UNITED STATES PATENT AND TRADEMARK OFFICE

APPLICATION NO.	FILING DATE	FIRST NAMED INVENTOR	ATTORNEY DOCKET NO.	CONFIRMATION NO.
09/838,348	04/19/2001	Randall W. Ojanen	K-1786	2490

Office Action Summary

DETAILED ACTION***Claim Rejections - 35 USC § 112***

Fig. 15

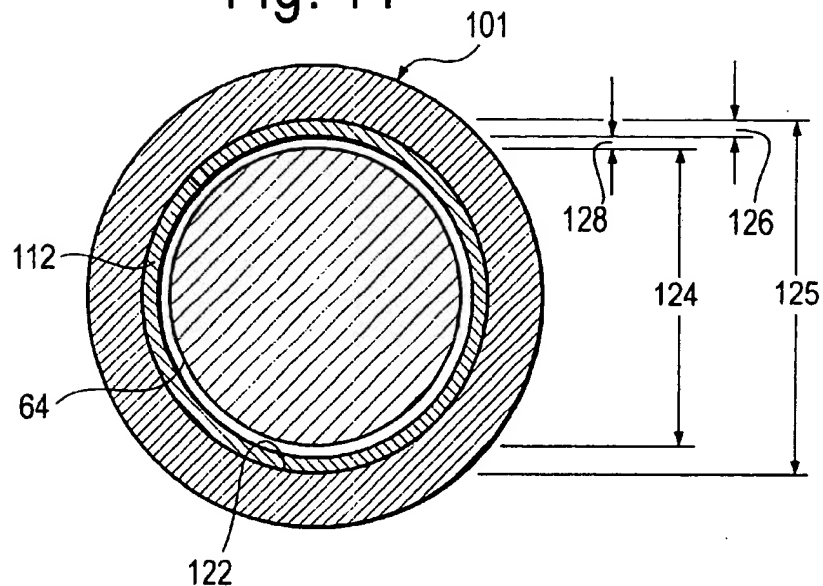
Sollami discloses a cutting tool assembly, said assembly comprising:
a cutting tool (10") a retainer sleeve (38") carried by the cutting tool, and including at least one radially outward protruding surface (31); wherein said retainer has a cylindrical circumference and a thickness dimension, the amount of radial projection of said protruding surface beyond the cylindrical surface of the retainer is between about 15 percent and about 30 percent of the thickness dimension of said retainer (see attached marked up Fig. 15).

Applicant argues that Sollami '652 does not show the dimension of the dimples as called for in the claims. The examiner disagrees and would like to direct applicant to attach marked up Figure 15, wherein the dimension of the dimples being about 15 to 30 percent the thickness of the retainer is clearly met.
